HARC Review 1301 Whitehead Street

Current Issues and Resolutions

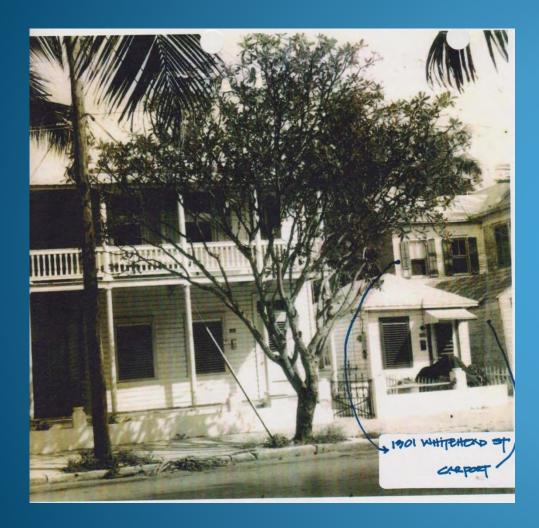
- Overall Scale of home
 - Removed the two story addition to the rear of the home
 - Replaced with a single story addition, its roof becomes a deck for the 2nd story
 - Move United Street Wall of 1st story in 6 inches so that addition stands apart from historical portion of home
 - Keep Rooflines so they remain at different elevations
- Overall the new plans
 - Make the historical element of the home and the rear of the home stand apart
- Placement of Accessory Structure
 - Stays the same distance from United Street
 - Moves increases setback from 4' 9" to 8 feet.
 - Movement allows for off street parking.
 - Historical evidence shows that structure has been moved several times in the past
